Seismic Walkdown Checklist (SWC)

Equipment ID No.: 1-DGAB

Equipment Description: AB EMERGENCY DIESEL GENERATOR OME-150-AB CONTROL

Project: DC Cook 1 SWEL

Equipment ID No.: 1-DGAB-INV

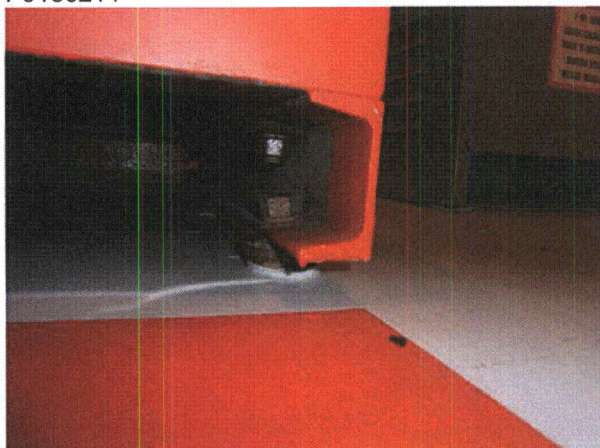
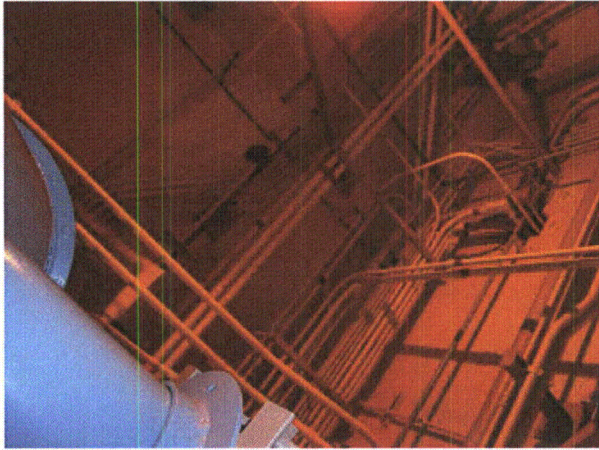
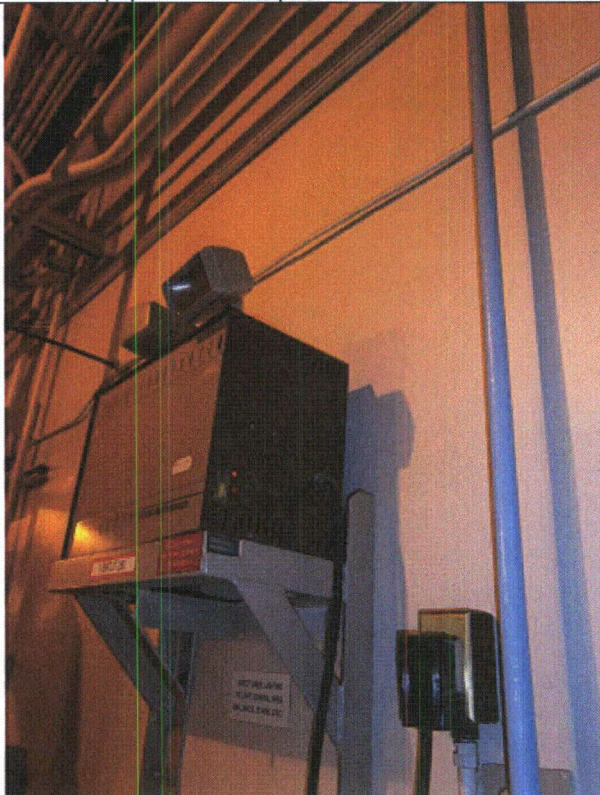
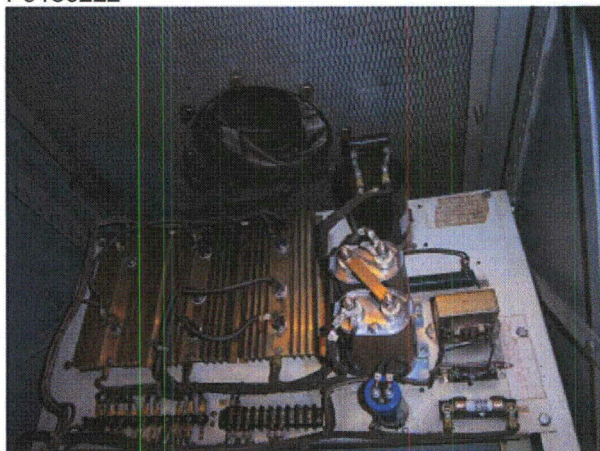
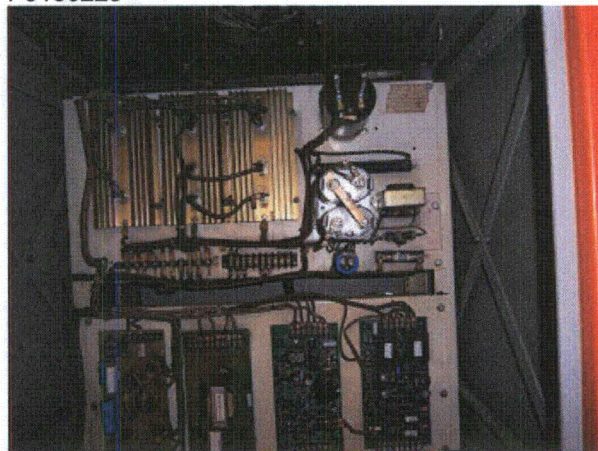
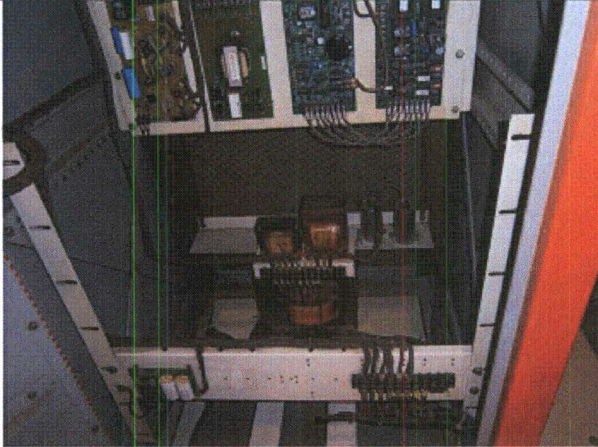
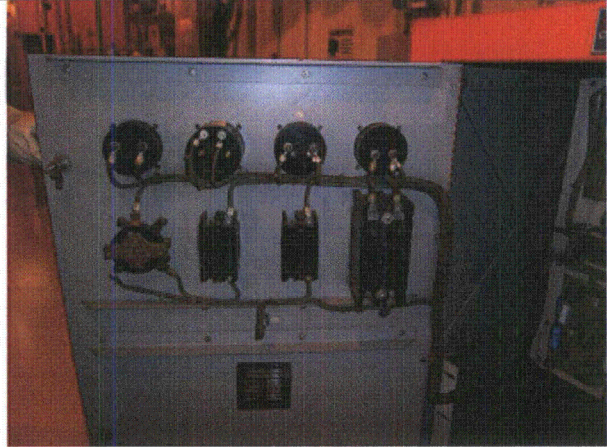
6. Based on the above anchorage evaluations, is the anchorage free of potentially adverse seismic conditions? Yes
Edge distance OK on bolts but looks small due to oversized washers underneath

Equipment ID No.: 1-ESW

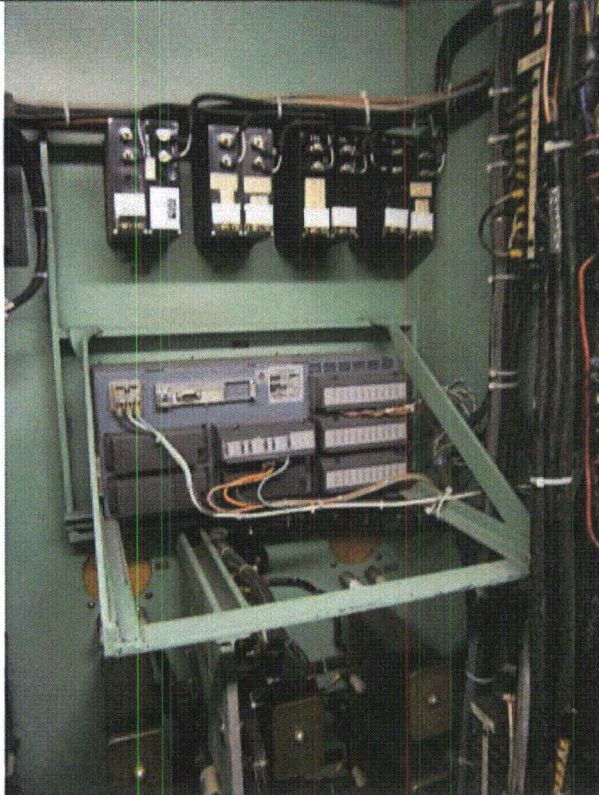
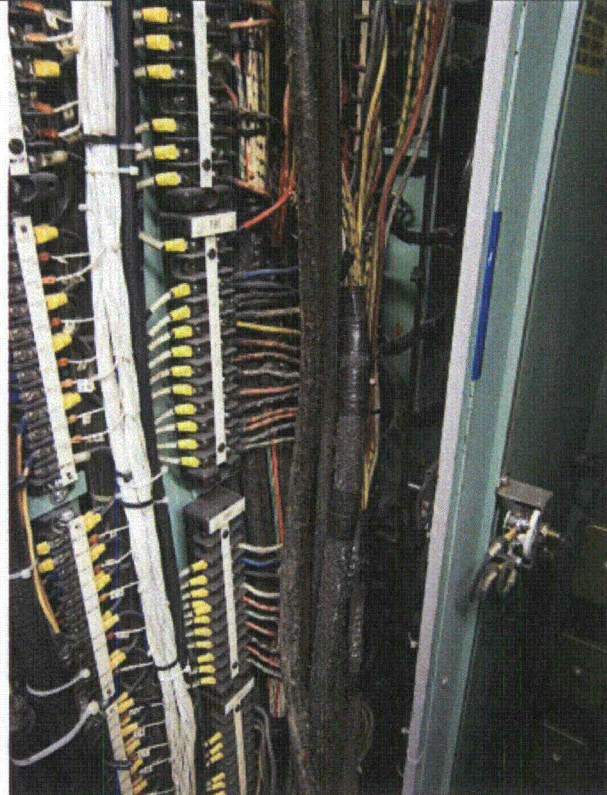
4. Is the anchorage free of visible cracks in the concrete near the anchors? Not Applicable
Welded to embedded plate with shim plates

8. Are overhead equipment, distribution systems, ceiling tiles and lighting, and masonry block walls not likely to collapse onto the equipment? Yes
Check ceiling tiles - OK - clipped per DWG 12-4070
